City of Redmond
2024 Water System Plan

Revised/Finalized: May 2025

Figure 2-1. Retail Service Area and Adjacent Purveyors

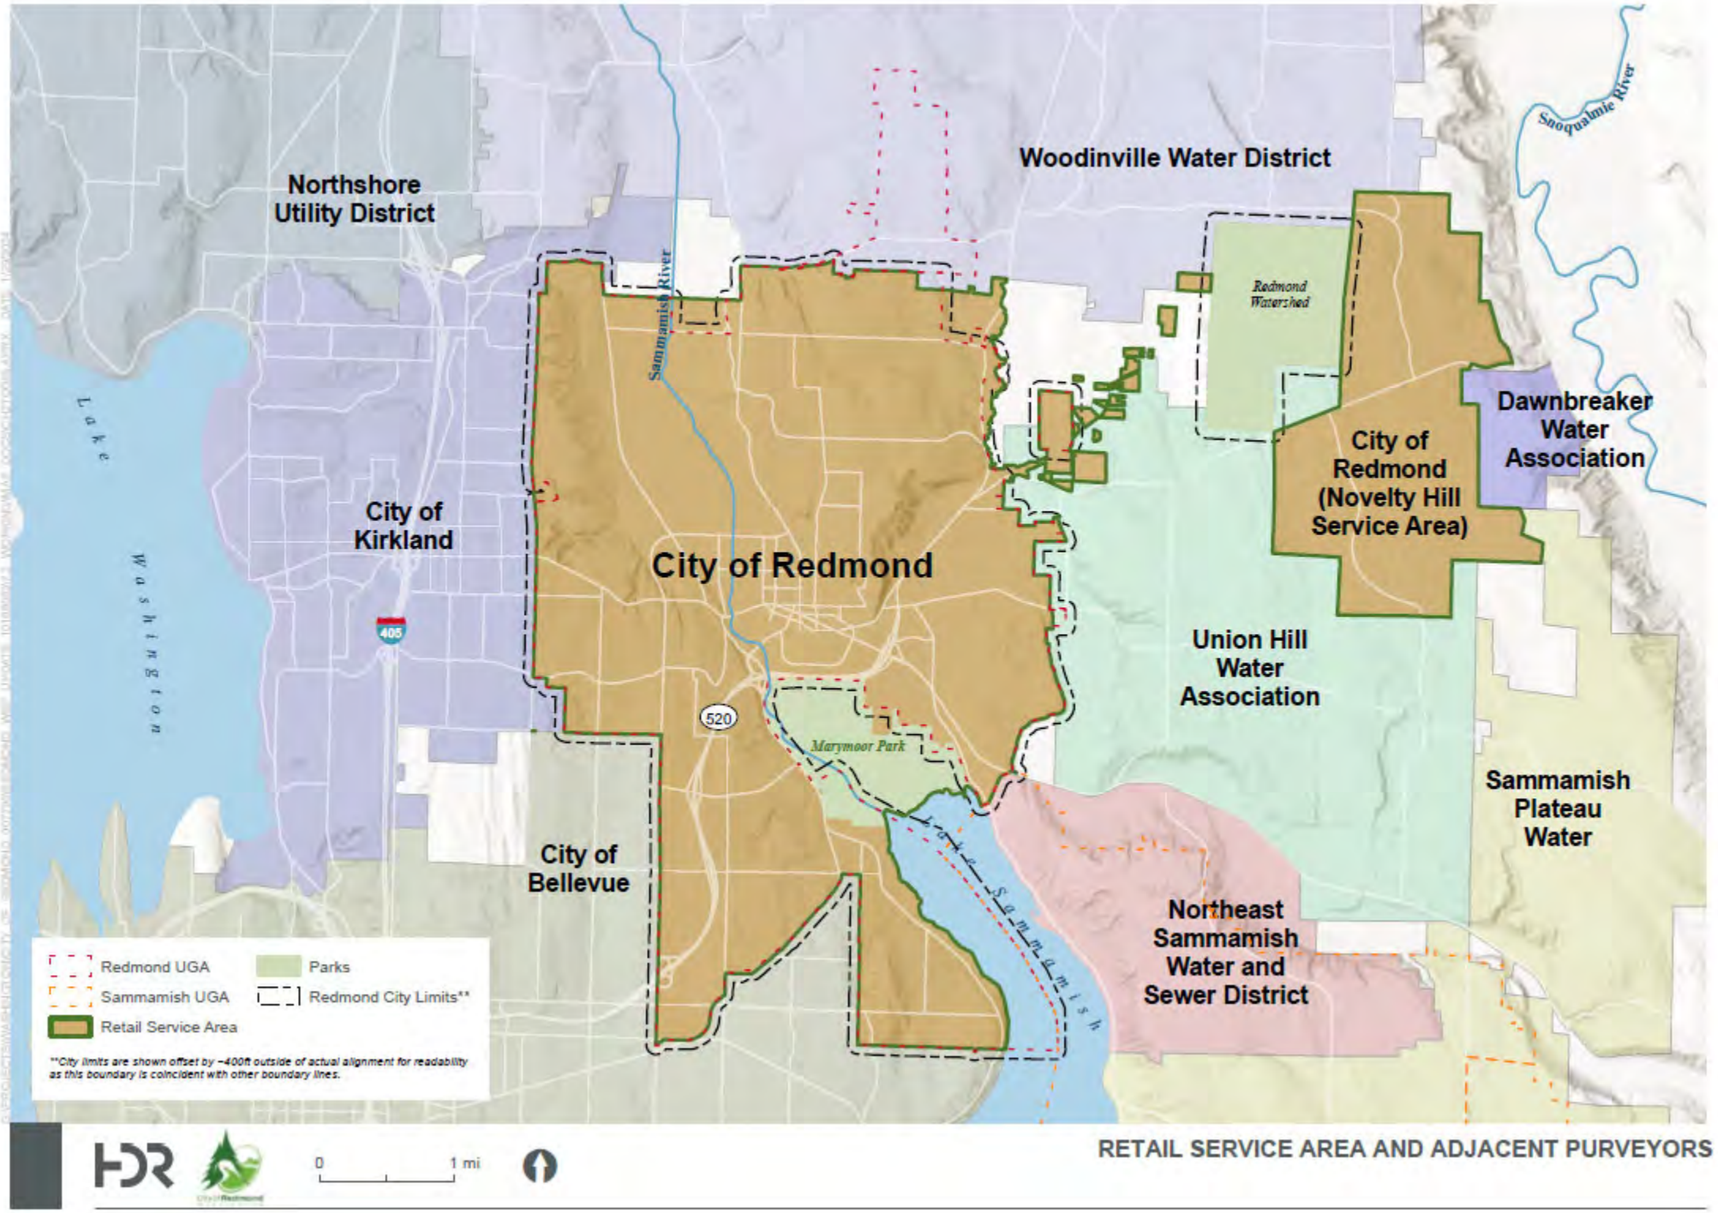
Comment No.	Comment	Response
1	Service Area Boundary: Please correct the City of Kirkland Retail Service Area boundary shown on Figure 2-1. Please see the encircled area on the attached Kirkland Existing Water System Map.	Figure has been revised per the comment.
2	South and North Rose Hill Ownership Percentages. Table 3-5, Page 3-35, shows Redmond's contractual ownership of the South and North Rose Hill Reservoirs as 21.5% and 29.2%, respectively. It appears these ownership percentages are from the 1993 Rose Hill Assumption Agreement. The 1997 Interlocal Operations and Maintenance Agreement, amended in 2005, shows that Redmond owns 29.4% of the Rose Hill South Reservoir and 34% of the North Rose Hill Reservoir. The percentage used to define the contractual storage available to the City of Redmond may affect the analyses and text contained in Chapters 10 and 12. Please see the highlighted portions of the attached Interlocal Operations and Maintenance Agreement.	Table 3-5 has been updated, and associated updates in other chapters have also been made.

5) Figure 2-1. Retail Service Area and Adjacent Purveyors. It is difficult to identify the Retail Service Area as the UGA and City Limits overlap with it. Can the map key be revised to identify the Retail Service Area more clearly in conjunction with other map attributes?

6) Section 2.2.1. Novelty Hill Service Area. While Figure 2-1 shows that the Novelty Hill Service Area is not contiguous/detached from other City service areas, the text does not explain why the City was the most appropriate water purveyor to provide water service to the residential developments in unincorporated King County. It would be beneficial to clarify when and why the City expanded its

8) Section 2.3.1. 2016 King County Comprehensive Plan. In review of Figure 2-1, it appears the City's service area encompasses unincorporated areas beyond the Novelty Hill Service area; however, the text doesn't appear to acknowledge this. While there is reference to the UGA, does the City's service area include any unincorporated Rural areas? It appears that Figure 2-3 shows a small portion of the service area being designated Rural area. Please clarify.

11) Section 2.4.1 Retail Service Area Boundaries. The text states that the City doesn't anticipate any major changes to its retail service area in the immediate future, however, the service area may be expanded to provide service to areas annexed into the City. While Figure 2-1 indicates that the unincorporated UGA adjacent to the City is not within the City's Retail Service Area, adding text to this section would clarify this situation. The text should also acknowledge that if the City expands its Retail Service Area, the water system plan would need to be amended to modify Figure 2-1 and update other appropriate text.

12) Section 2.4.1 Retail Service Area Boundaries. The text references an area that the City provides water service to that is not within and will not be included in its service area. The text references Figure 2-1 to identify the location of this area, however, in review of the figure, it doesn't appear this area is identified. The text also references discussions with Union Hill Water District and Woodinville Water District for future service discussions. Is there a timeframe in which this issue will be resolved? Please clarify?

13) Section 4. Planning Data and Demand Forecast. The text states that Redmond retails water in two areas; the City Service Area and the Novelty Hill Service Area, however, in review of Figure 2-1, it appears that there are other unincorporated areas within the City's Retail Service Area, including the unincorporated area north of NE 116th in the proximately of 184th Ave. NE. Please clarify.

6	Section 2.2.1. Novelty Hill Service Area. While Figure 2-1 shows that the Novelty Hill Service Area is not contiguous/detached from other City service areas, the text does not explain why the City was the most appropriate water purveyor to provide water service to the residential developments in unincorporated King County. It would be beneficial to clarify when and why the City expanded its service area to service these developments. This explanation may justify the irregular service area boundary.	Text added to section 2.2.1 to broadly describe the history.
7	Section 2.3.1. 2016 King County Comprehensive Plan. The text provides a detailed description of the County's Comprehensive Plan policies and identifies adopted land use designations on Figure 2-3., however, it is appropriate to also provide the acreage associated with each land use designation and identify the development status of the acreage (i.e., vacant, developed, underdeveloped).	A new table (Table 2-1 has been added with this information.

8	Section 2.3.1. 2016 King County Comprehensive Plan. In review of Figure 2-1, it appears the City's service area encompasses unincorporated areas beyond the Novelty Hill Service area; however, the text doesn't appear to acknowledge this. While there is reference to the UGA, does the City's service area include any unincorporated Rural areas? It appears that Figure 2-3 shows a small portion of the service area being designated Rural area. Please clarify.	Yes, small portions of the RSA to the east and northeast serve rural unincorporated King County. Text was added in section 2.4.1 (Retail Service Area Boundaries) to further describe these areas within the RSA in unincorporated King County, and that policy UT-4 in the City's comprehensive plan described how rural water service will be provided.

12	Section 2.4.1 Retail Service Area Boundaries. The text references an area that the City provides water service to that is not within and will not be included in its service area. The text references Figure 2- 1 to identify the location of this area, however, in review of the figure, it doesn't appear this area is identified. The text also references discussions with Union Hill Water District and Woodinville Water District for future service discussions. Is there a timeframe in which this issue will be resolved? Please clarify?	These parcels show up in figure 3-1, along the transmission main. These have now also been brought back into the other maps and shown as within the RSA. Text revised in section 2.4.1 to clarify that these parcels, by definition, are in the RSA, but no other parcels abutting the line outside the RSA will be provided service.
13	Section 4. Planning Data and Demand Forecast. The text states that Redmond retails water in two areas; the City Service Area and the Novelty Hill Service Area, however, in review of Figure 2-1, it appears that there are other unincorporated areas within the City's Retail Service Area, including the unincorporated area north of NE 116th in the proximately of 184th Ave. NE. Please clarify.	Added a brief statement in the first paragraph of Section 2.4.1. to note service is provided to areas beyond the City limits that are in the Well Service Area. The WSA is within the "City Service Area," therefore, this clears that statement for use in chapter .

Figure 2-3. King County Land Use in the Redmond Area

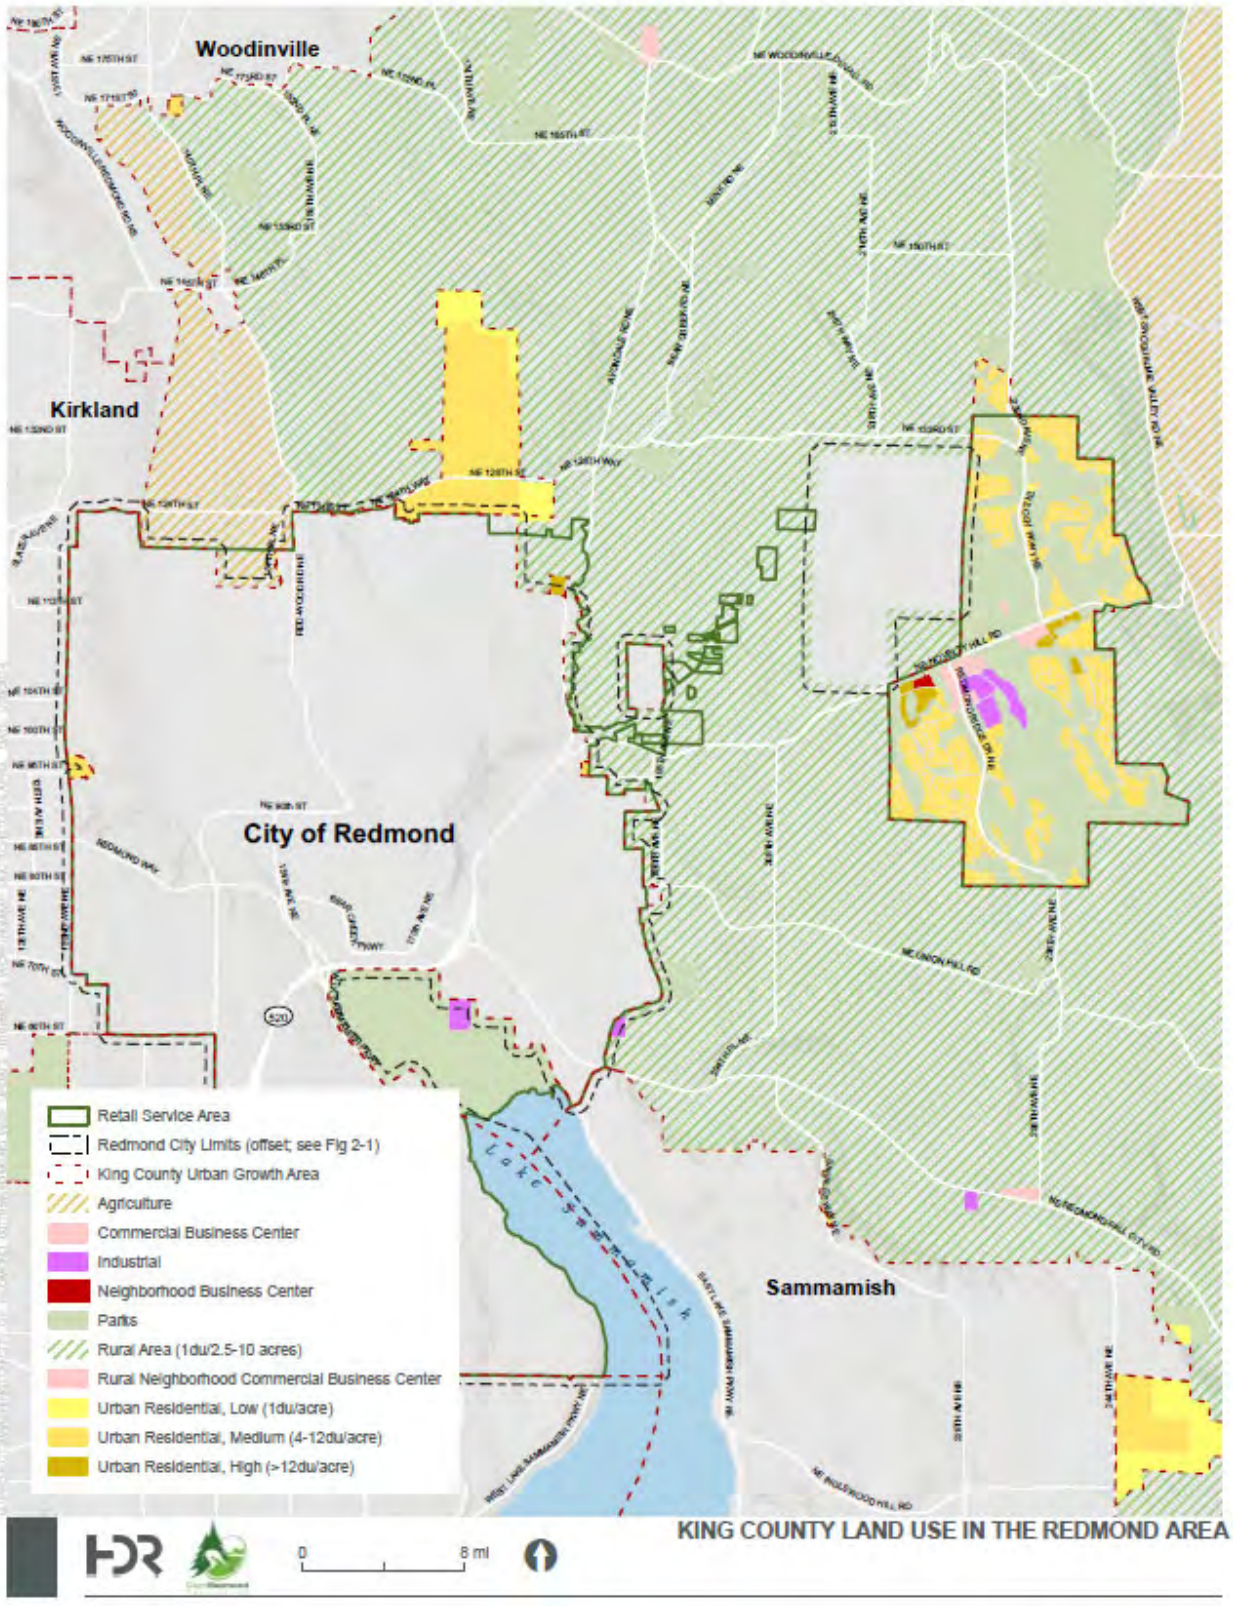
7) Section 2.3.1. 2016 King County Comprehensive Plan. The text provides a detailed description of the County's Comprehensive Plan policies and identifies adopted land use designations on Figure 2-3., however, it is appropriate to also provide the acreage associated with each land use designation and identify the development status of the acreage (i.e., vacant, developed, underdeveloped).

Figure 2-4. Redmond Comprehensive Land Use Plan

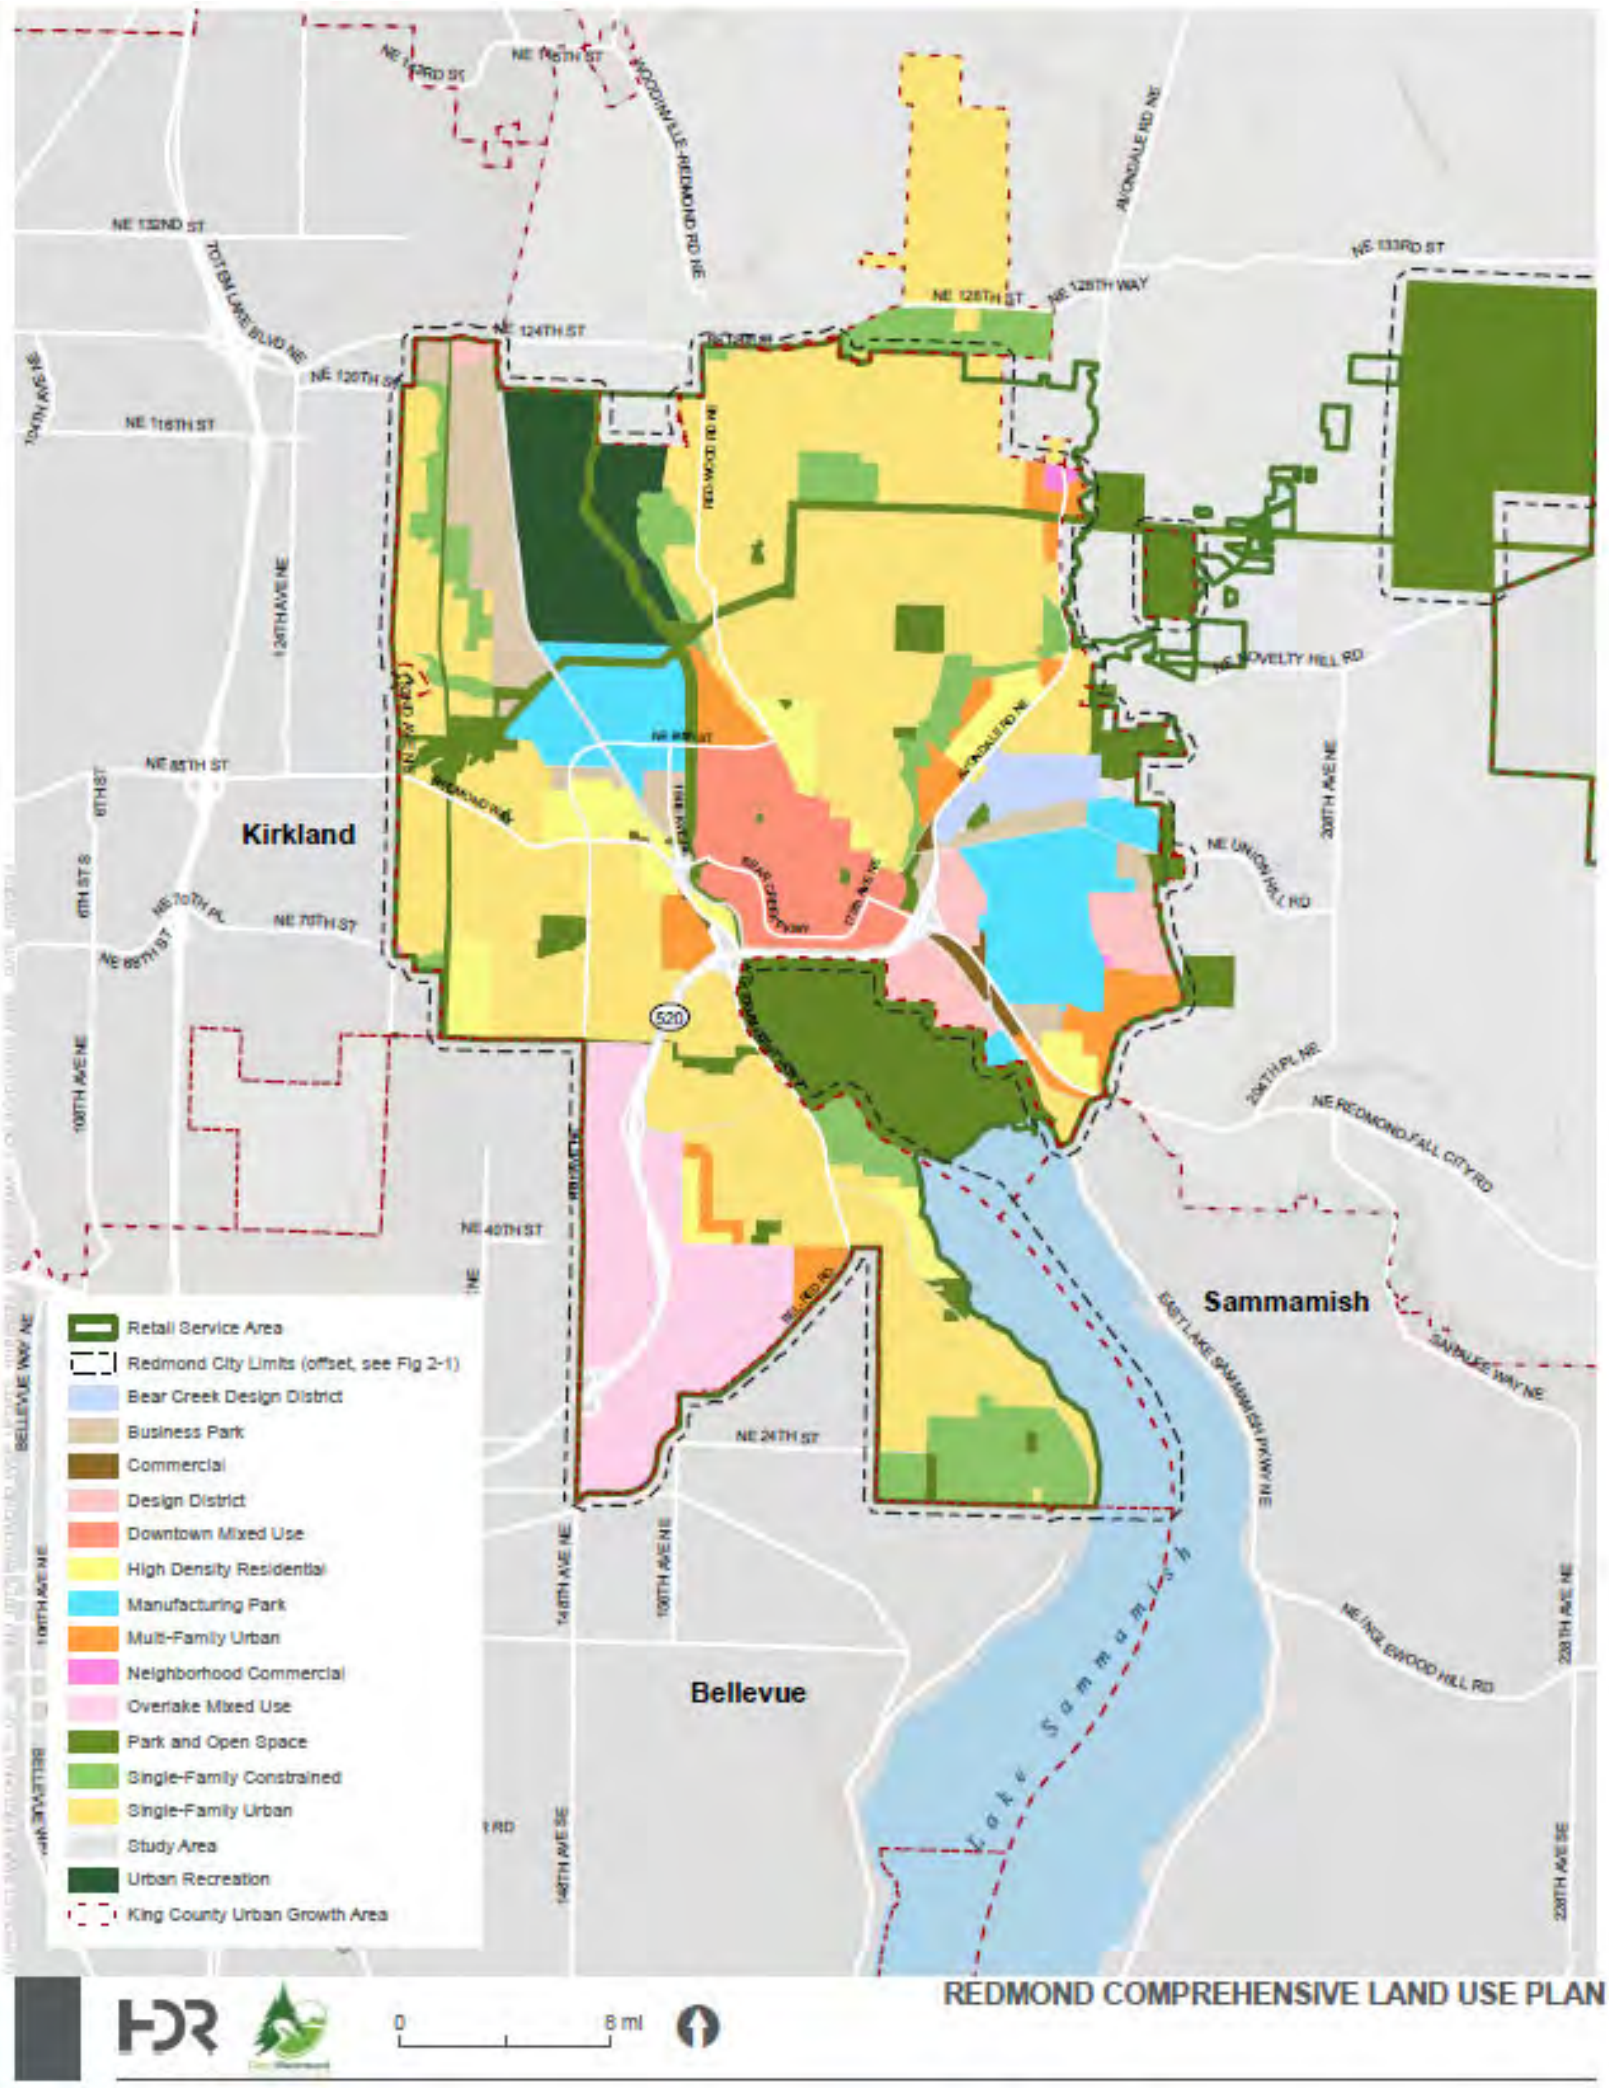
10) Figure 2-4 Redmond Comprehensive Land Use Plan. It is difficult to identify the Retail Service Area as the UGA and City Limits overlap with it. Can the map key be revised to identify the Retail Service Area more clearly in conjunction with other map attributes?

10	Figure 2-4 Redmond Comprehensive Land Use Plan. It is difficult to identify the Retail Service Area as the UGA and City Limits overlap with it. Can the map key be revised to identify the Retail Service Area more clearly in conjunction with other map attributes?	Figure revised, as noted in a previous response.
11	Section 2.4.1 Retail Service Area Boundaries. The text states that the City doesn't anticipate any major changes to its retail service area in the immediate future, however, the service area may be expanded to provide service to areas annexed into the City. While Figure 2-1 indicates that the unincorporated UGA adjacent to the City is not within the City's Retail Service Area, adding text to this section would clarify this situation. The text should also acknowledge that if the City expands its Retail Service Area, the water system plan would need to be amended to modify Figure 2-1 and update other appropriate text.	All the Redmond UGA that is not served by the City is already served by other purveyors. Added text to 2.4.1 indicating that the service area may be expanded to provide service to areas annexed into the City in the future <u>that are not currently served by another purveyor</u>. A statement was added that changes to the RSA would require a plan amendment and approval.
